**From:** SM-Defra-RESP-notifications (DEFRA)  
**Sent:** 27 May 2025 17:07  
**To:** Elaine Marshall  
**Cc:** Kate Cummins  
**Subject:** EPR/GP3828LK/A001 Happylands Farm - We Need More Information About Your Application (not duly made request for further information) CRM:0270093

**Application reference: EPR/GP3828LK/A001**

**Facility: Happylands Farm, Owersby Moor, Market Rasen, Lincolnshire LN8 3YN**

From the current site drainage plan:

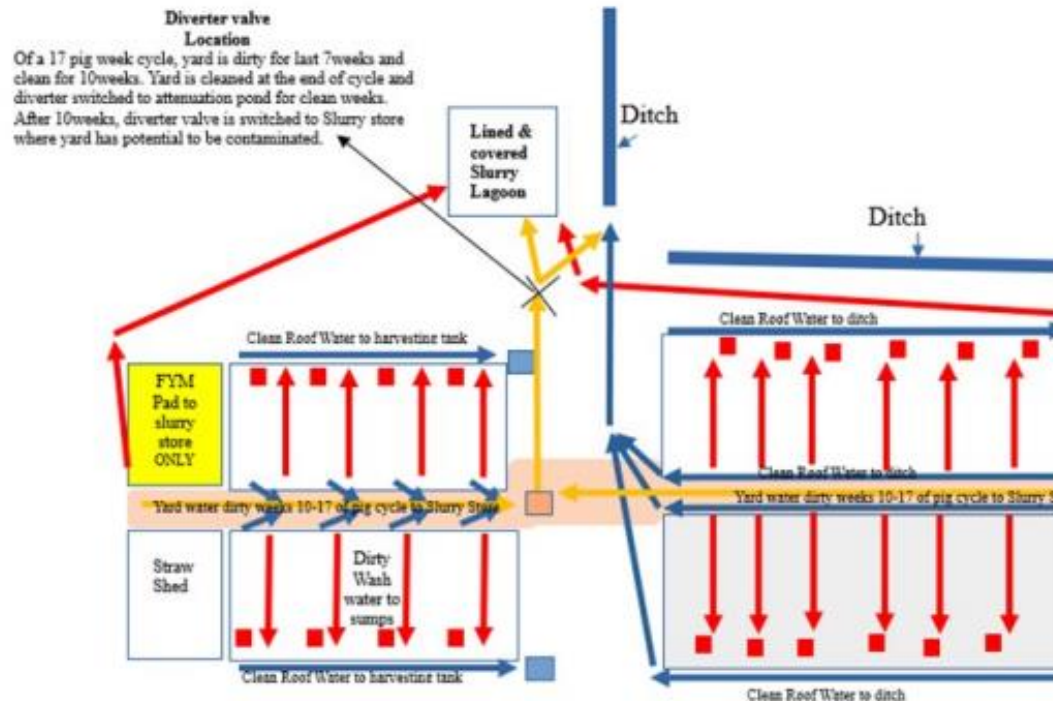
**7. Site drainage** – it mentions in the Technical Standards (TS) document that there are buildings 5 – 8, but these aren't indicated on the site plan or site drainage plan. It also mentions free draining soakaway but this isn't on the plan either, nor is D1 indicated (there are two ditches indicated on the drainage plan submitted, both to the north, one running vertically and one horizontally). In addition the diverter valve is not indicated on the drainage plan. Please provide further clarity on the drainage and a revised TS and site drainage plan with the correct information.
